## Korenix JetNet PoE Switch- JetNet 4706f SOFTWARE RELEASE Notes

### About This Software Version

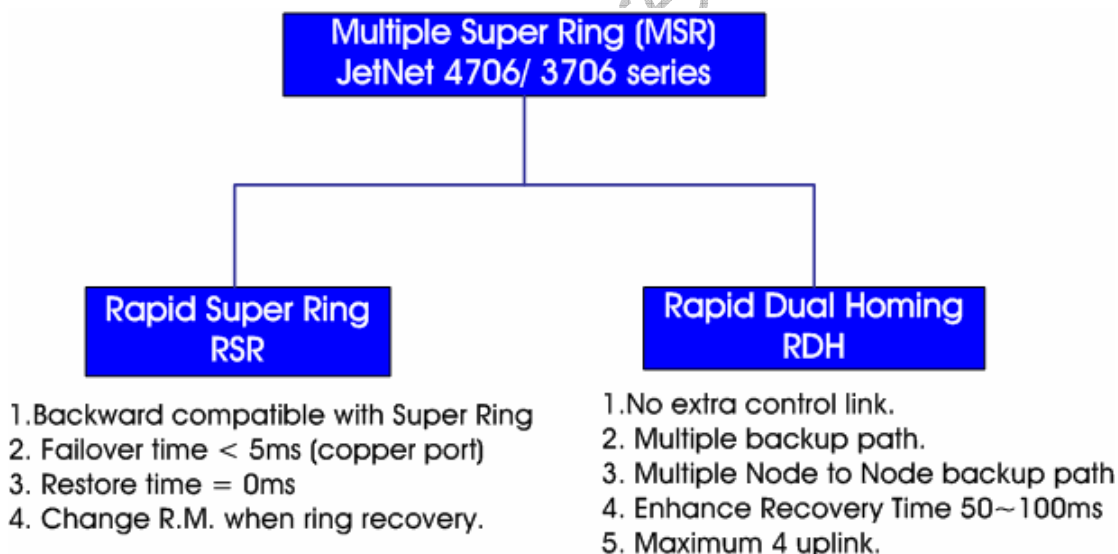
- Support Multiple Super Ring function (M.S.R.) which include enhanced Rapid Super Ring (R.S.R.) and Rapid Dual Homing (R.D.H.) functions. The following diagram show the support features.
